BID PROJECT NO. 1216-11

COUNTY OF MONROE
DEPARTMENT OF TRANSPORTATION

ADDENDUM NO. 1

JOHN STREET EXTENSION

SHEET NO.
FIGURE 8

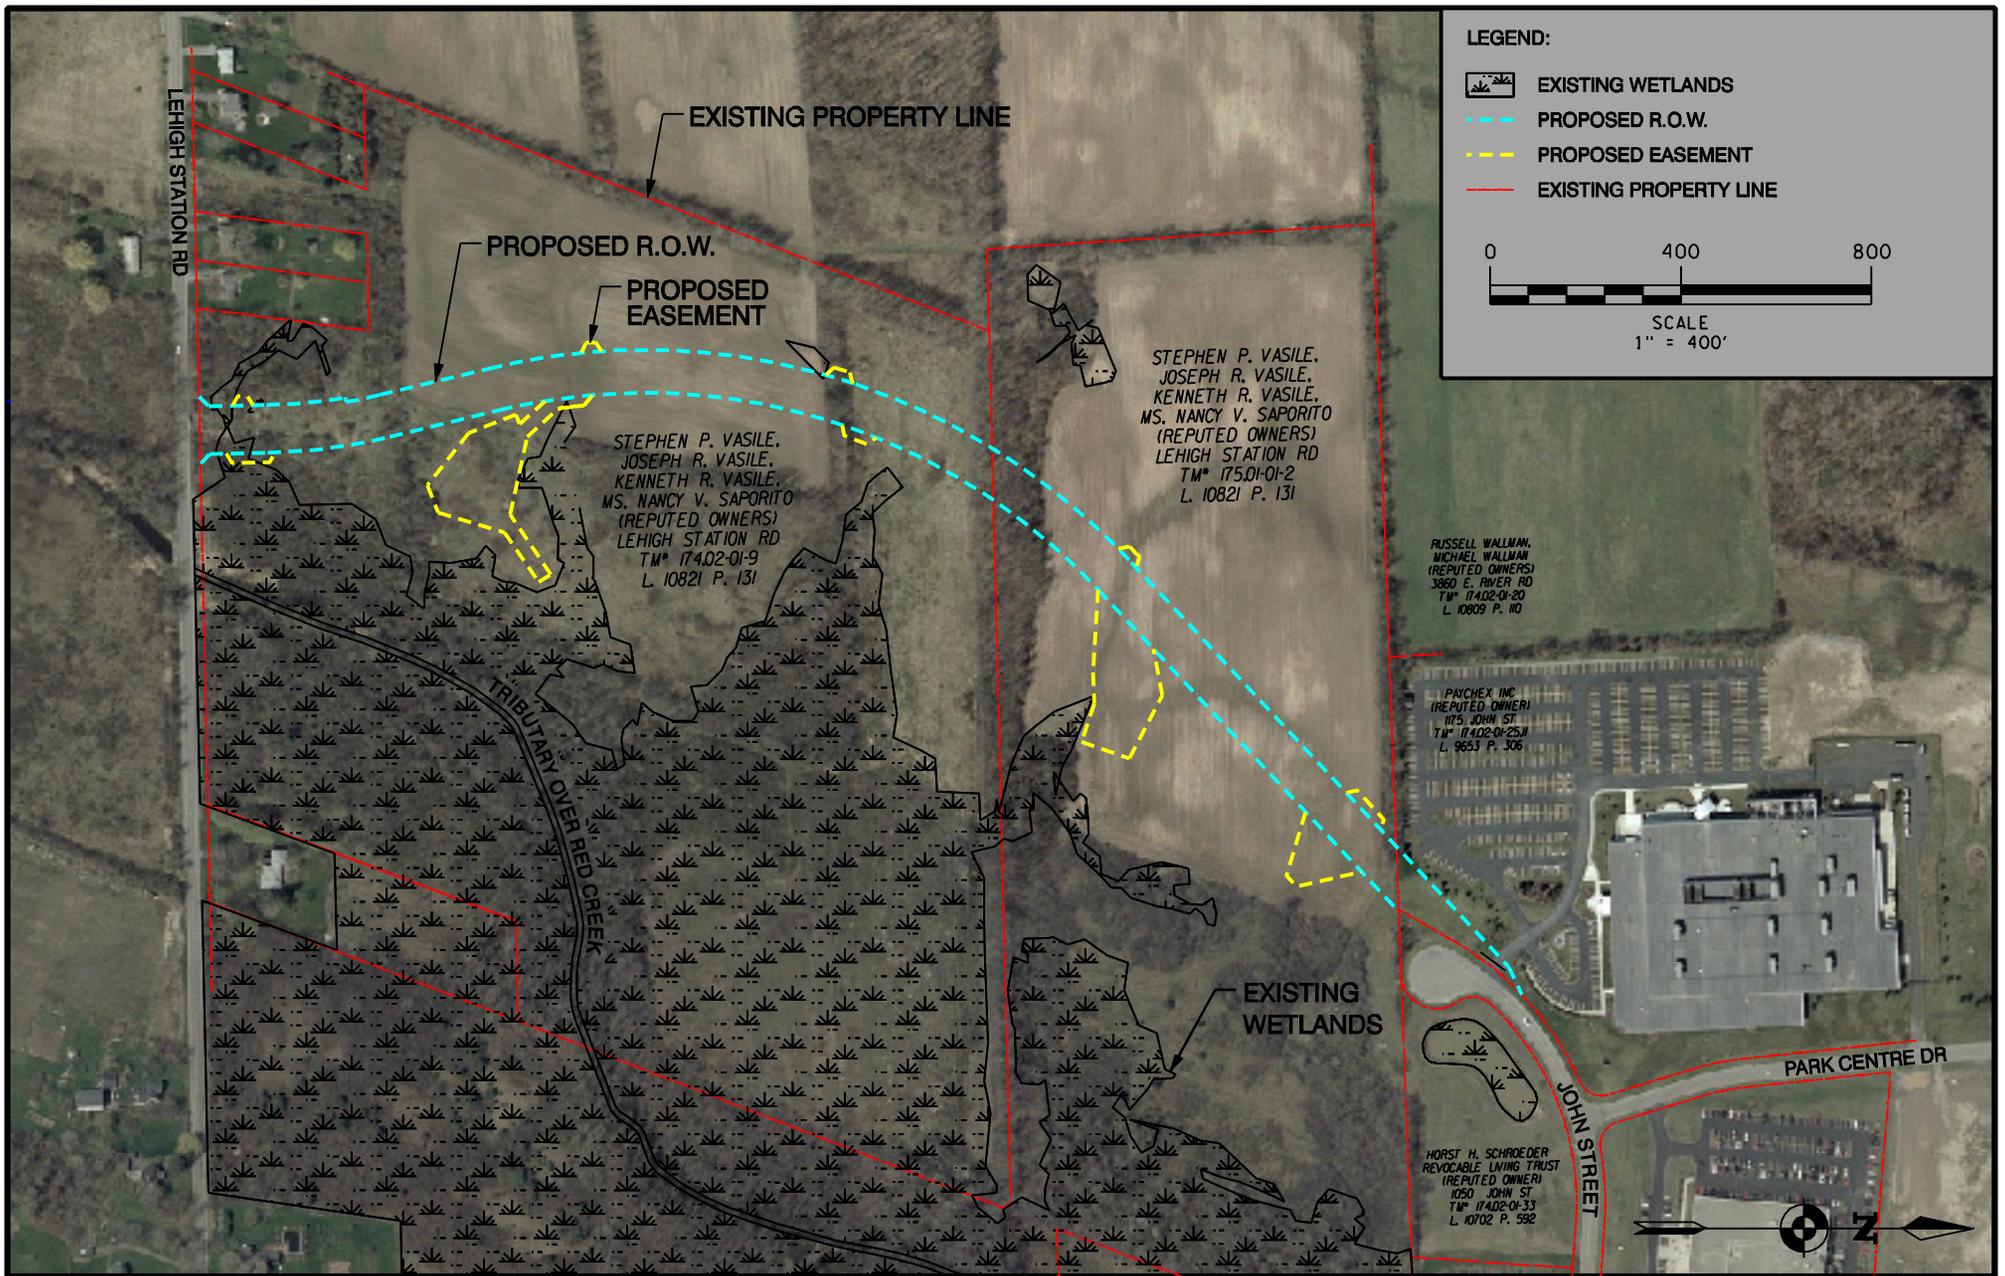
12. ADD the enclosed SWPPP notes to the Supplemental Information section.
13. ADD the enclosed Figure 8 to the Supplemental Information section.
14. REPLACE the text “DC” with “CD” on the Highway Cross Sections Special Note Page in the Special Notes section.

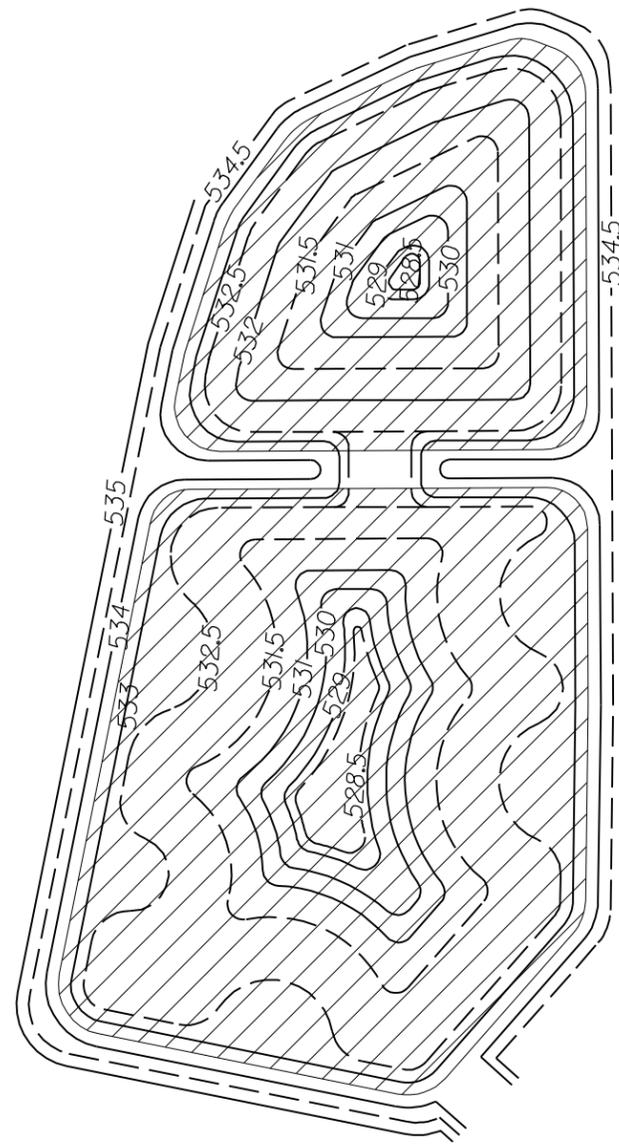
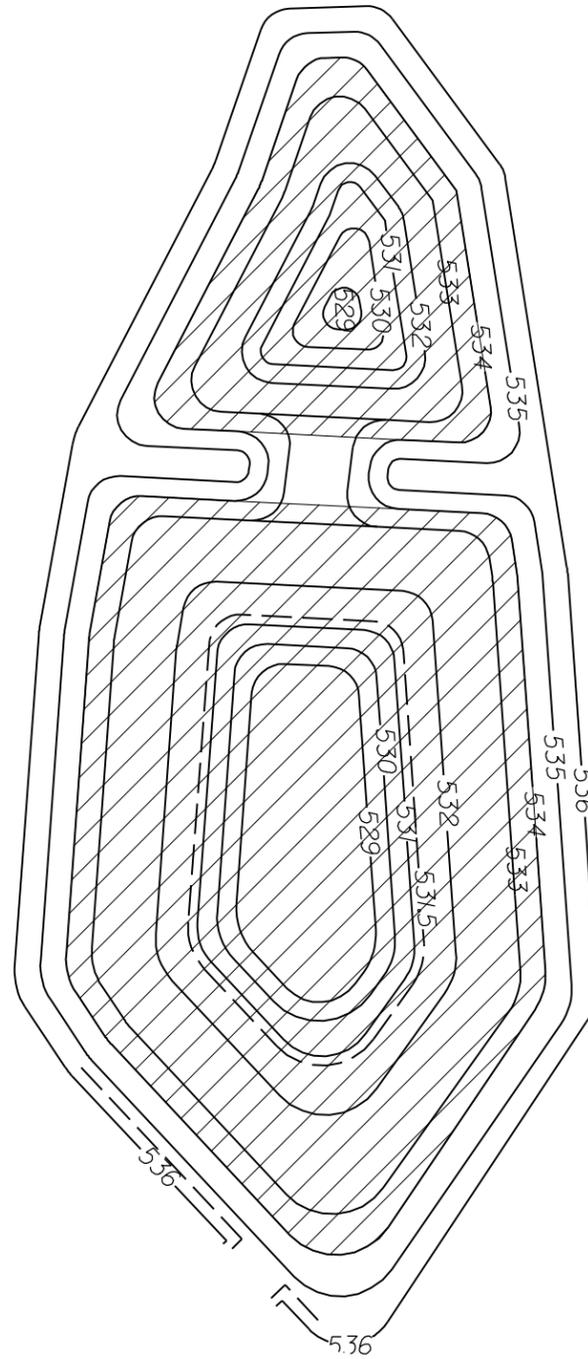
1. REPLACE existing DWG. No. MD-05, Sheet 9 with the enclosed DWG. No. MD-05R1, Sheet 9.
2. DELETE Construction Staging Note #1 on DWG. No. WTC-01, Sheet 9.
3. REPLACE the Water Main Note #8 on DWG. No. MD-02, Sheet 17 with the following note: “When the new main is placed in service, the existing water main shall be capped and abandoned in place and will not require grout fill.”
4. REPLACE item quantities on DWG. No. QNT-01, Sheet 6 as follows:
 - a. Item 203.02 quantity is 17422 CY for Base Bid
 - b. Item 203.03 quantity is 12624 CY for Base Bid
 - c. Item 304.12 quantity is 5203 CY for Base Bid
 - d. Item 402.097212 quantity is 125 QU for ADD Alternate #2
 - e. Item 603.9812 quantity is 1213 LF for Base Bid
 - f. DELETE item 610.02030106 for Base Bid
 - g. Item 610.050100MO quantity is 214 LB for Base Bid
